**Confirmed Minutes of the 254th Meeting
of the Advisory Council on the Environment (ACE)
on 8 August 2022 at 2:30 p.m.**

Item 4 : Report and follow up discussion on the 154th Environmental Impact Assessment Subcommittee Meeting - EIA report on "Technical Study on Partial Development of Fanling Golf Course Site – Feasibility Study"
(ACE Paper 11/2022)

To facilitate ACE’s further deliberation on the above EIA project, the Project Proponent is requested to provide additional information in writing on the following issues with reference to the comments provided by Members at the meeting –

沼澤林地的主要水源分析 Main Water Sources of Swampy Woodland

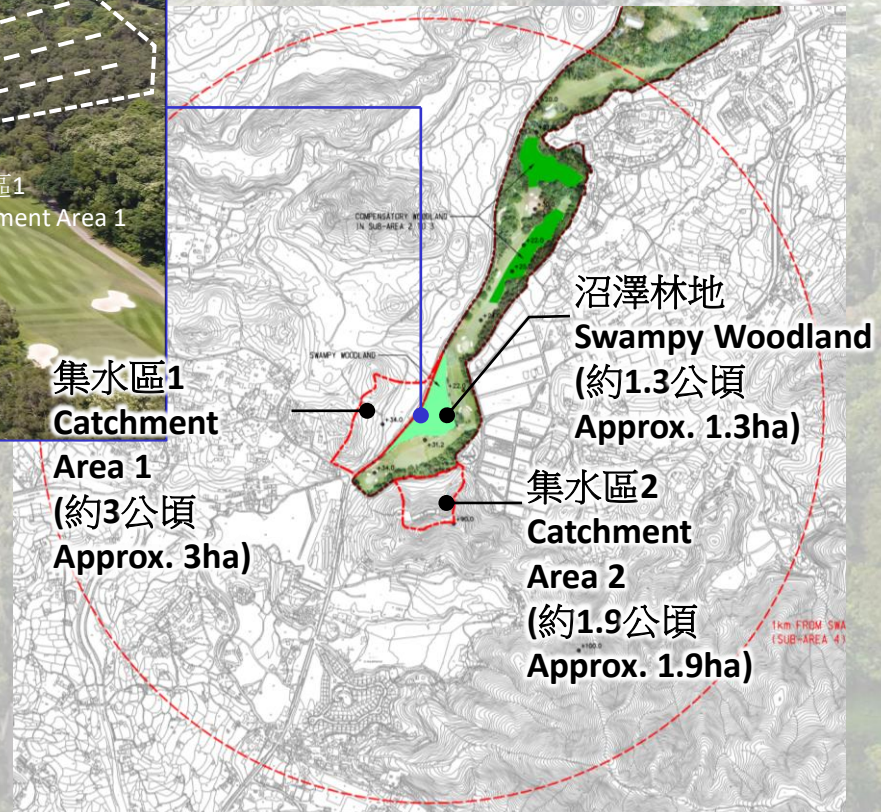
- elaborate with scientific expertise, methodology and data the hydrological impact on the Chinese Swamp Cypress and woodland habitats in sub-areas 3 and 4 with consideration of the change due to the proposed development, tree plantation as mitigation measures, and available water sources in both wet and dry seasons in these sensitive areas;
- provide hydrology impact assessment and mitigation measures to demonstrate the feasibility of the proposed layout of the housing blocks and amenity buildings (with consideration to allow reasonable substructure / foundations and impervious paving areas as well) for the 12,000 residential units;

<ul style="list-style-type: none"> • Adaptive Management: Adjustments and improvements. <p>The proposed development in Sub-area 1 would not pose adverse hydrology, hydrological and light impacts on the other sub-areas will be further elaborated in the following sections.</p>
	<p>2. Hydrology and Hydrological Impact</p> <p>- elaborate with scientific data the hydrological impact on the Chinese Swamp Cypress and woodland habitats in sub-areas 3 and 4 with consideration of tree plantation as mitigation measures, and available water sources in both wet and dry seasons in these sensitive areas;</p>	<p>Demonstration of Successful Compensatory Planting in Sub-Areas 2-3 based on Historical Records of Plantation of Woodlands in Old Course after 1945:</p> <p>According to historical records, including the aerial photos taken since 1945, the existing woodlands within the Old Course, except the Chinese Swamp Cypress within the swampy woodland, were rebuilt from 50's to 80's, as most of the woodlands were destroyed during World War II, though the Chinese Swamp Cypress has been in existence for over a century. The historical records well demonstrate that the swampy woodland in Sub-Area 4 is not affected by the plantation within the Old Course. Plantation of compensated trees within Sub-Areas 2-3 will not produce any threat to the Chinese Swamp Cypress.</p> <p>Demonstration of Main Water Sources of the Swampy Woodland not to be affected by Housing Development in Sub-Area 1 and Compensatory Woodland in Sub-Areas 2-3 based on the Hydrological Mechanism:</p> <p>Our hydrological impact assessment has already shown that the groundwater of Sub-Area 1 flows towards the north side, i.e., away from Sub-Areas 2 to 4, based on the geological condition of Sub-Area 1. Given that Sub-Area 1 and Sub-Area 2 is divided by hillocks and woodland with higher general level than both Sub-Area 1 & Sub-Area 2, surface runoff of Sub-Area 1 would not contribute to the groundwater of Sub-Areas 2 to 4. The housing development of Sub-Area 1 will not affect the hydrology of Sub-Areas 2 to 4.</p> <p>The Chinese Swamp Cypress is located within the swampy woodland in Sub-Area 4. The approximate level of the swampy woodland is +22mPD. Based on the existing topography, the existing hillock with minimum catchment area of 1.9 ha. and maximum level of +90mPD approximately in the southeast side of Sub-Area 4 and the New Course of FGC with minimum catchment area of 3 ha. and with approximate level of +34mPD in the north-west side of Sub-Area 4 are much higher than the swampy woodland. The hillock and the New Course are the main water catchments of the swampy woodland. Runoff from these two catchments is discharged into the swampy woodland. The catchment area plan is shown in Attachment 3.</p> <p>The general level of Sub-Area 3 is +24mPD approximately, which is only slightly higher than the general level of Sub-Area 4 of +22mPD. Contribution of water to the swampy woodland in Sub-Area 4 is not significant due to the similar topography of Sub-Area 4 as Sub-Areas 2 to 3.</p> <p>Based on our site observation, there is a water channel along the east side of the swampy woodland. The water flows from the south side towards the north side, i.e., towards Sub-Area 3. The water channel is well connected with the swampy woodland and is one of the main water sources of the swampy woodland. Direction of flow of the water channel further demonstrates that the main source of water to</p>

<p>the swampy woodland in Sub-Area 4 is not from Sub-Areas 2-3.</p> <p>Irrigation Water Demand for Compensated Trees:</p> <p>The planation within the PDA is under intensive maintenance. HKGC irrigates the planation within the golf course by reclaimed water supplied from Shek Wu Hui Sewage Treatment Works (SWHSTW). The daily consumption is 3,000m³ approximately. Based on this ratio, the irrigation water demand for the over 1,000 trees within Sub-Area 1 is 174m³ per day. It is reasonable to assume that the additional water demand irrigating the 1,000 compensated trees in Sub-Areas 2-3 will also be 174m³ per day.</p> <p>The additional water demand for irrigating the compensated trees can be satisfied by SHWSTW, which will have reclaimed water capacity of over 73,000 m³/day, which is 419 times the water demand for irrigating the compensated trees or supplementing the potential groundwater lost of Sub-Areas 2-3 due to the compensated trees, if any.</p> <p>With the Habitat Management Plan to irrigate the compensated trees by the reclaimed water provided by SWHSTW, the hydrology of Sub-Area 4, especially to the swampy woodland and the Chinese Swamp Cypress will not be affected.</p>

Establish **Optimized** Tree protection zone, **with additional buffer zone (e.g. 3m extra space)**

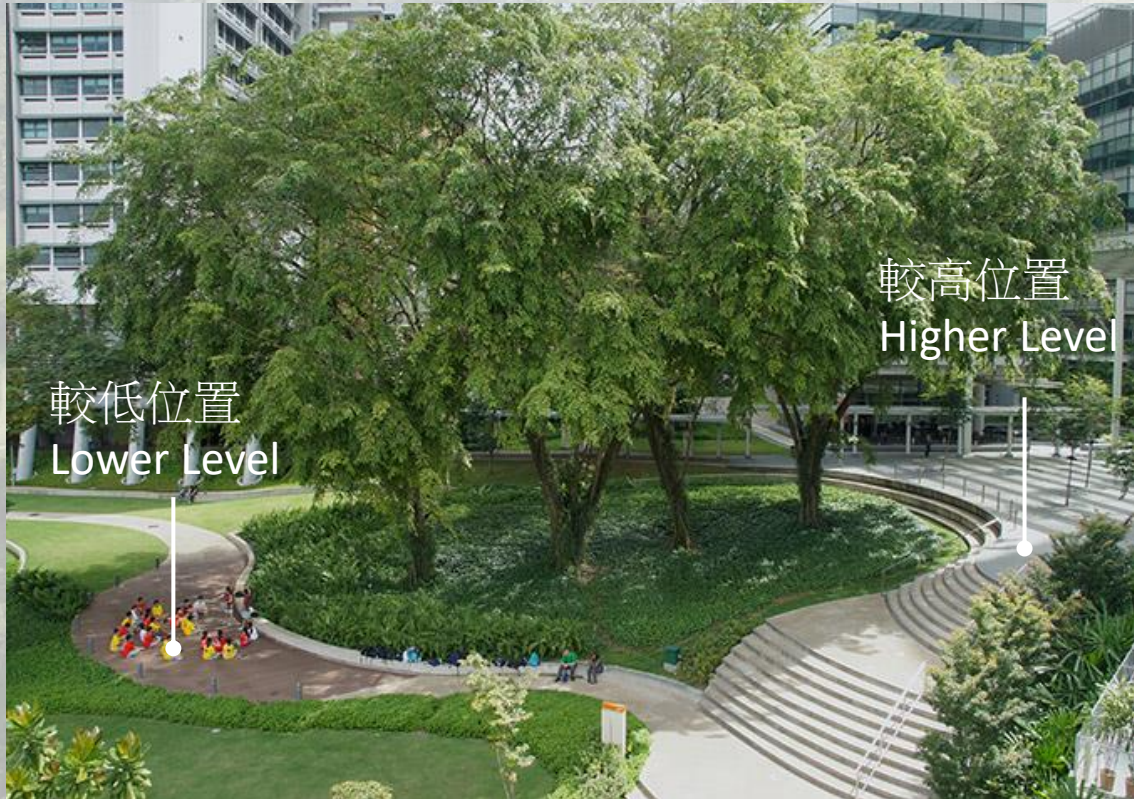
- elaborate the tree felling plan with the aim to minimise the number of trees to be felled through strategically adjusting the design, disposition and layout for the housing blocks and amenity buildings;

建立有額外緩衝區(例如外加3米)的優化樹木保護區

例子 Example: 在太子道東的大樹 Big Tree in Prince Edward Road East

Drawing title
PLANTING PALETTE (1)

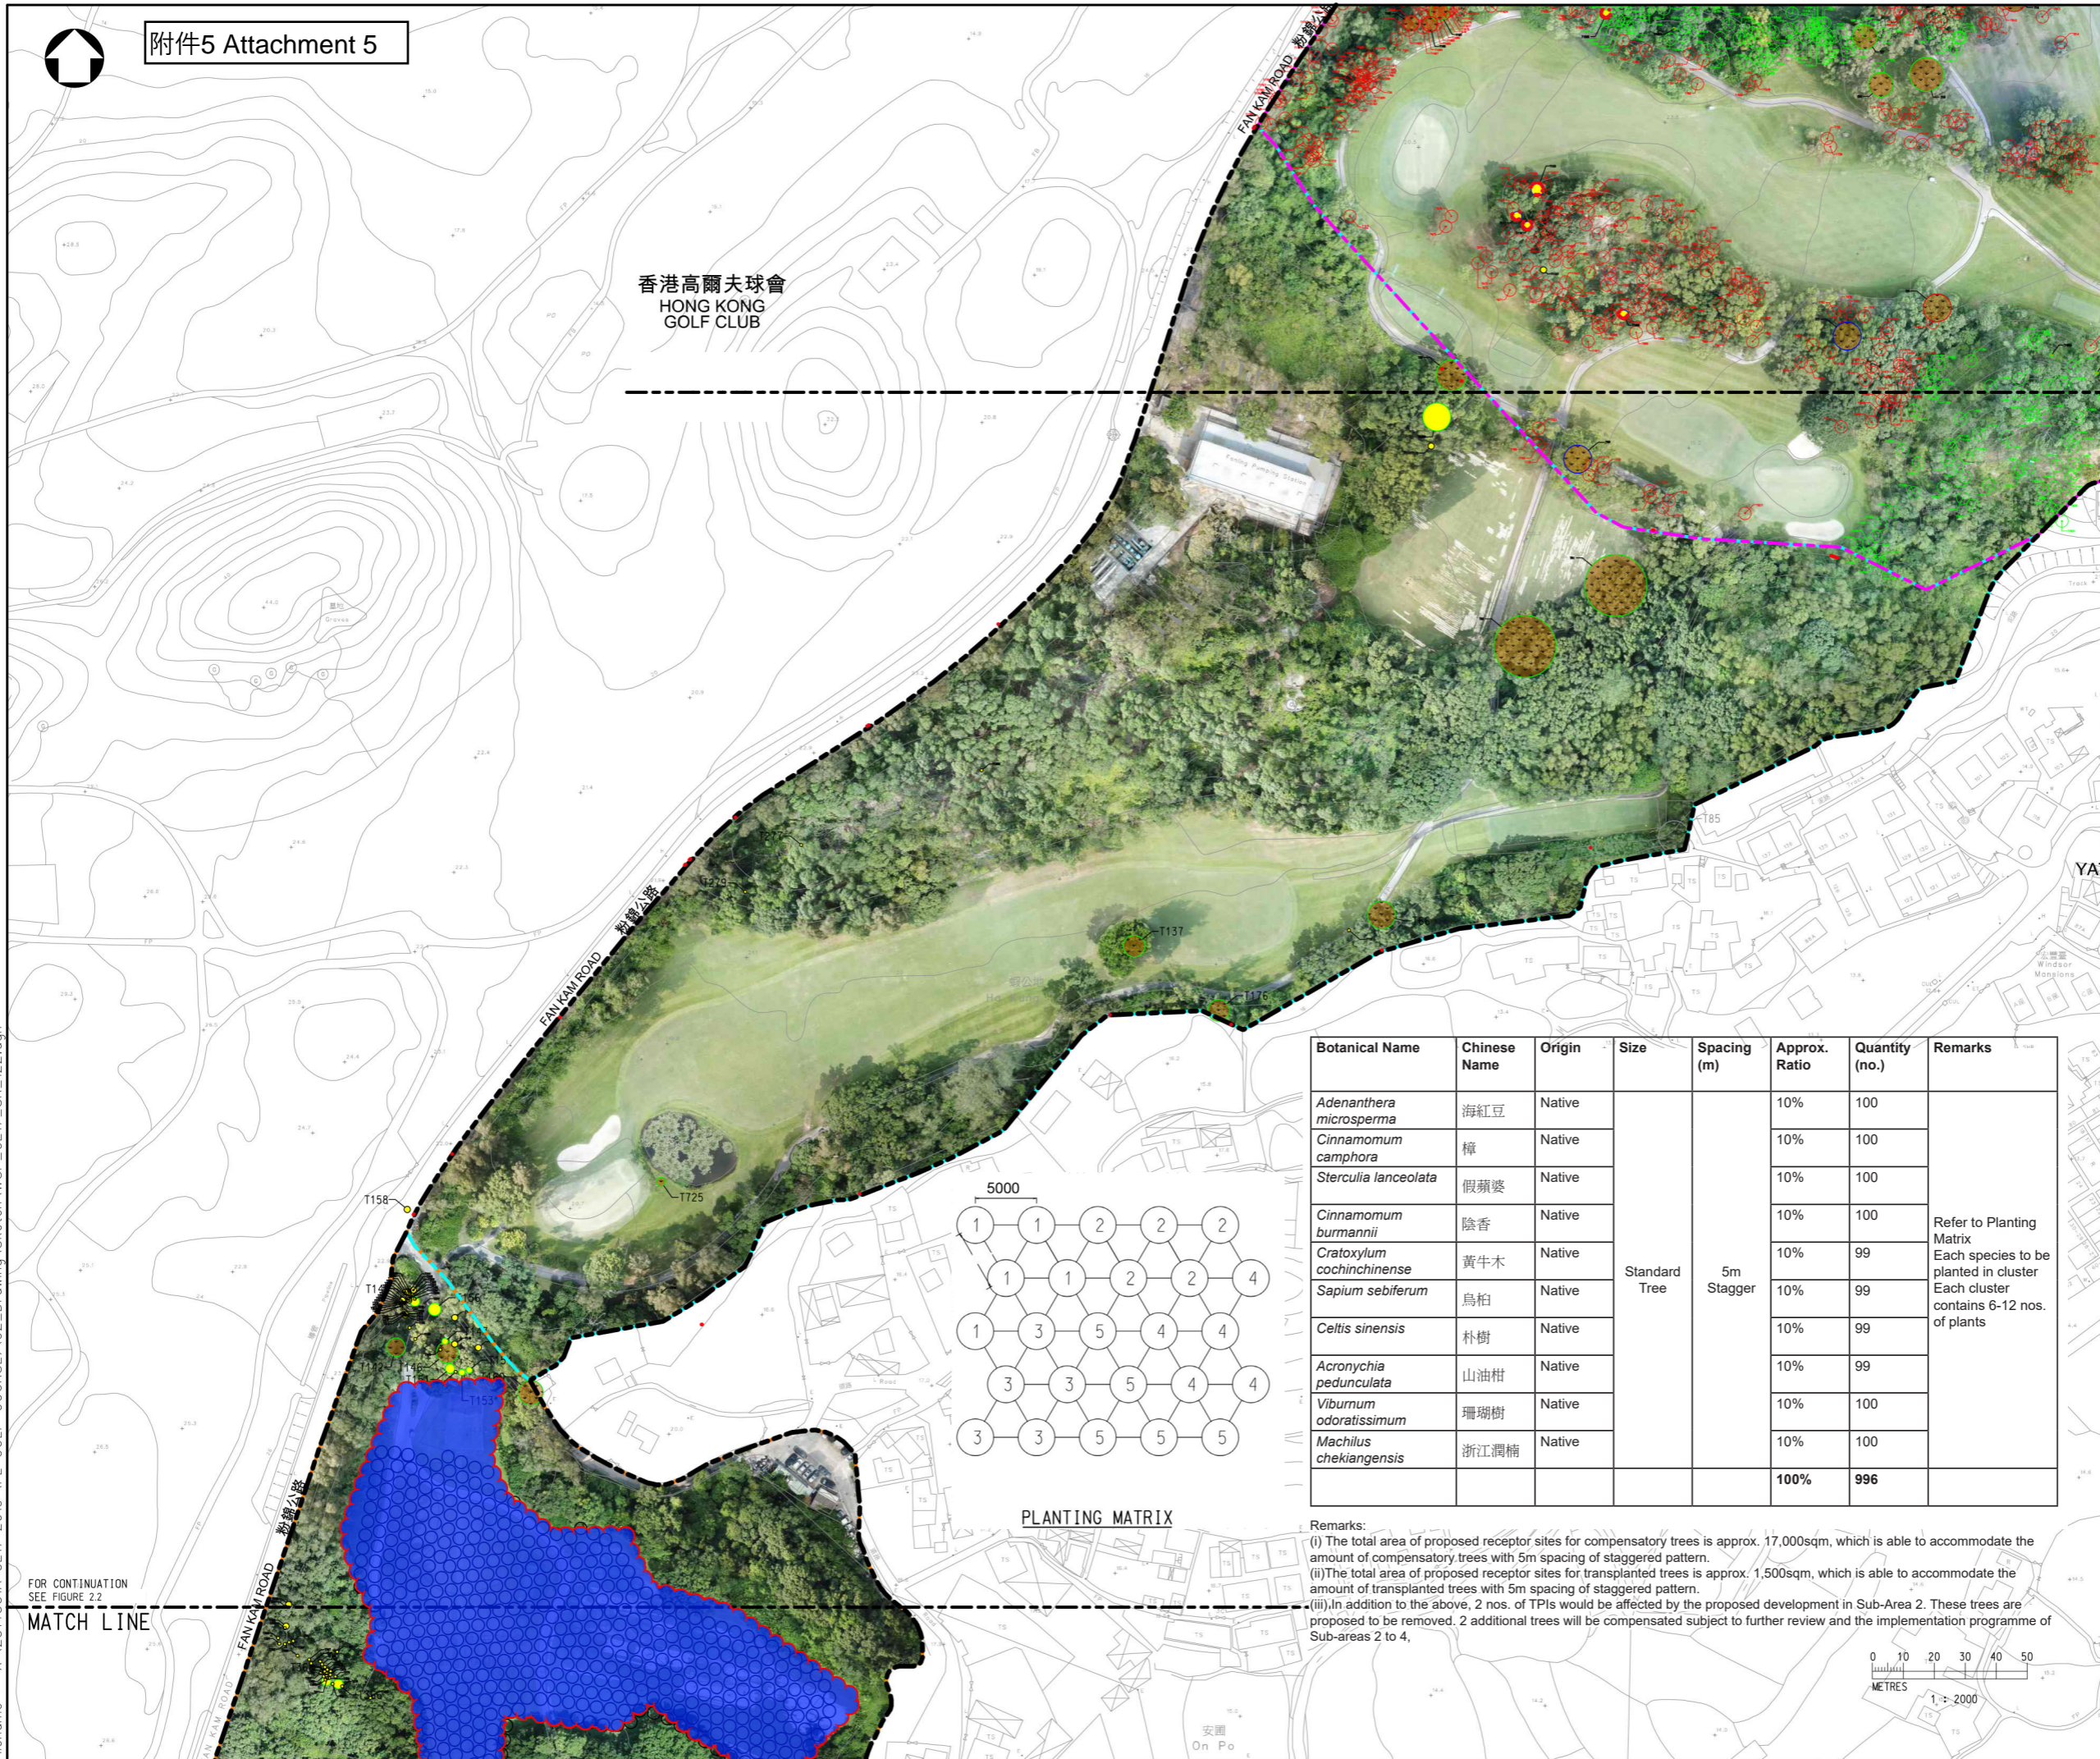
- provide detailed tree compensation plan including the numbers, species and tentative locations of compensatory tree planting to illustrate that the compensation would not result in adverse ecological impacts on sub-areas 2 to 4 while also considering plantation of native fruit trees and trees as habitats for fauna to enhance the ecosystem; and

Botanical Name	Chinese Name	Origin	Size	Spacing (m)	Approx. Ratio	Quantity (no.)	Remarks
<i>Adenanthera microsperma</i>	海紅豆	Native	Standard Tree	5m Stagger	10%	100	Refer to Planting Matrix Each species to be planted in cluster Each cluster contains 6-12 nos. of plants
<i>Cinnamomum camphora</i>	樟	Native			10%	100	
<i>Sterculia lanceolata</i>	假蘋婆	Native			10%	100	
<i>Cinnamomum burmannii</i>	陰香	Native			10%	100	
<i>Cratoxylum cochinchinense</i>	黃牛木	Native			10%	99	
<i>Sapium sebiferum</i>	烏柏	Native			10%	99	
<i>Celtis sinensis</i>	朴樹	Native			10%	99	
<i>Acronychia pedunculata</i>	山油柑	Native			10%	99	
<i>Viburnum odoratissimum</i>	珊瑚樹	Native			10%	100	
<i>Machilus chekiangensis</i>	浙江潤楠	Native			10%	100	
					100%	996

- (i) The total area of proposed receptor sites for compensatory trees is approx. 17,000sqm, which is able to accommodate the amount of compensatory trees with 5m spacing of staggered pattern.
- (ii) The total area of proposed receptor sites for transplanted trees is approx. 1,500sqm, which is able to accommodate the amount of transplanted trees with 5m spacing of staggered pattern.
- (iii) In addition to the above, 2 nos. of TPIs would be affected by the proposed development in Sub-Area 2. These trees are proposed to be removed. 2 additional trees will be compensated subject to further review and the implementation programme of Sub-areas 2 to 4.

照明眩光評估 Lighting Glare Assessment

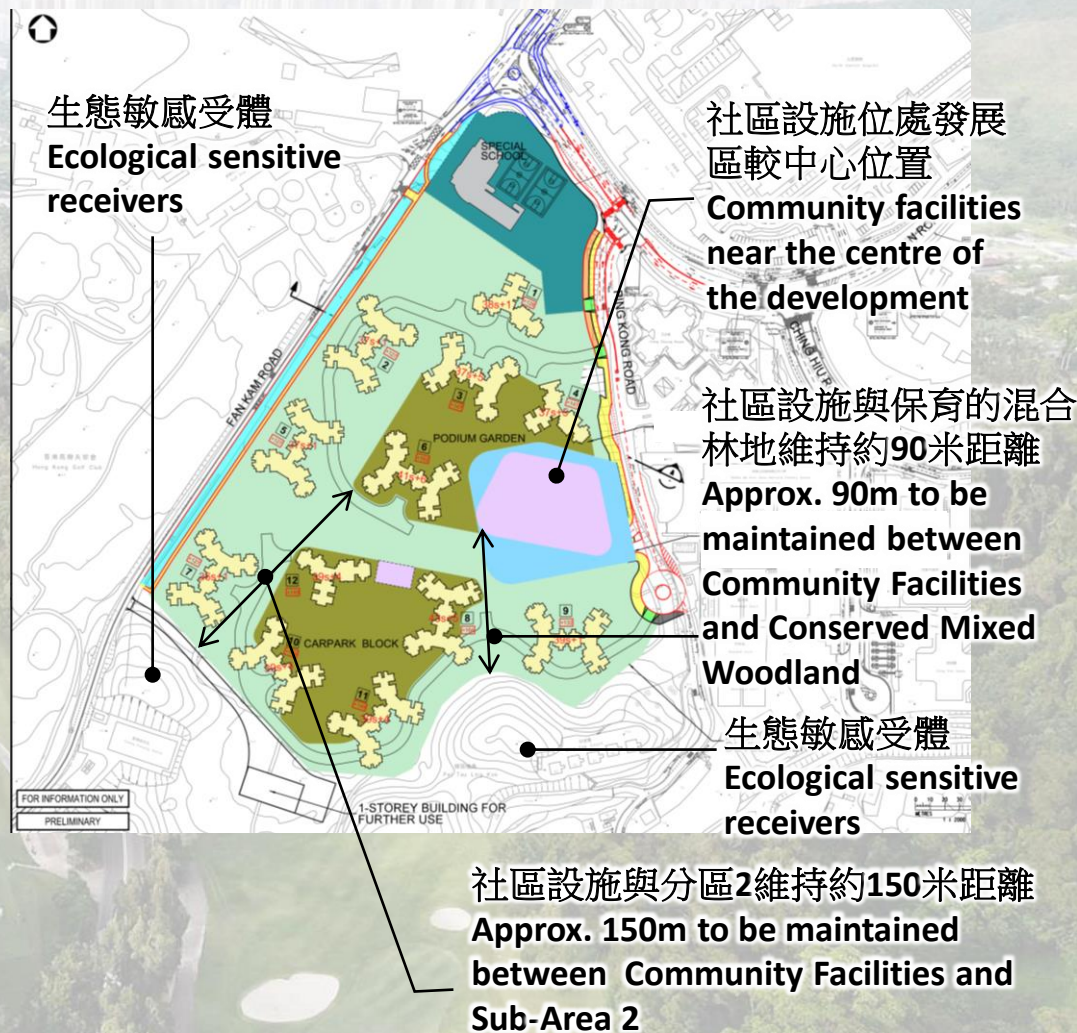
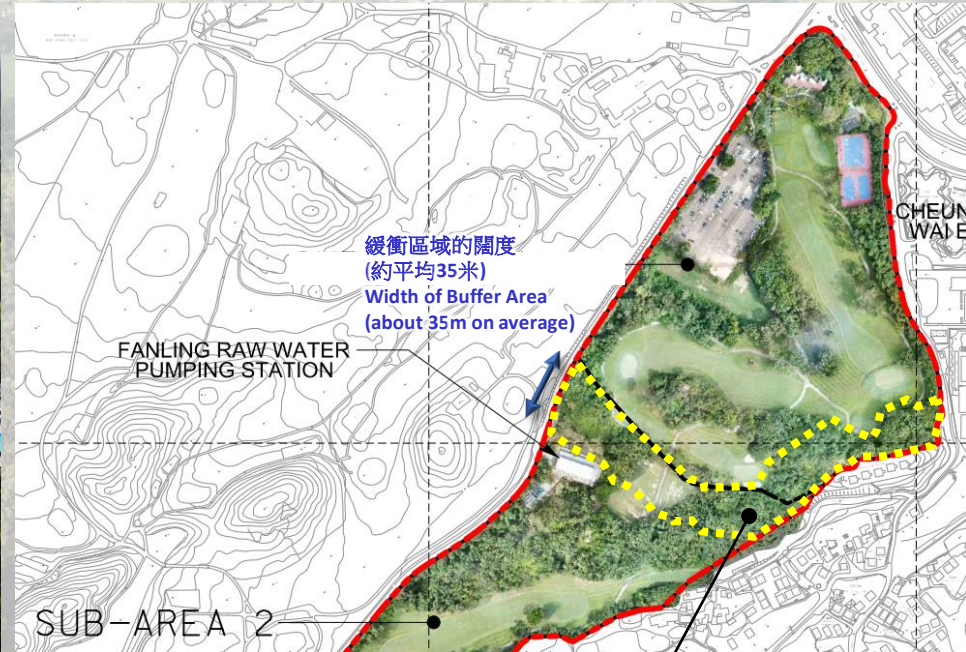
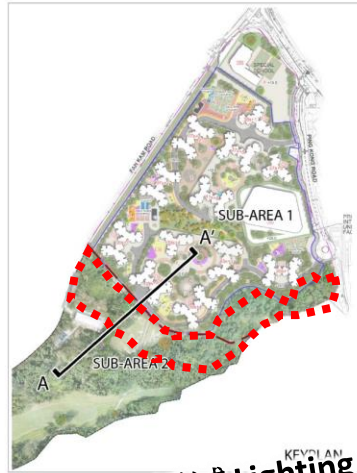
- provide detailed assessment of the lighting glare impact with the support of scientific data including the design, disposition, location and layout of the proposed housing blocks and amenity buildings, on the woodland habitat and associated fauna of the project site in both the construction and operational phases.

以一般街燈在距離地面10米作基準計算：
With a typical street lamp at 10 m from ground as the basis:

地點 Location	最短距離 (米) Nearest Distance (m)	光線強度的減少 (倍) Reduction in Light Intensity (times)
社區設施至保留的混合林地 Community Facilities to Preserved Mixed Woodland	90	1/81
社區設施至分區2 Community Facilities to Sub- Area 2	150	1/225

景觀緩衝區 – 直接光線影響將被第一排的樹木/植物屏蔽
Landscape Buffer Area – Direct light impact would be screened off by the first row of trees/vegetation
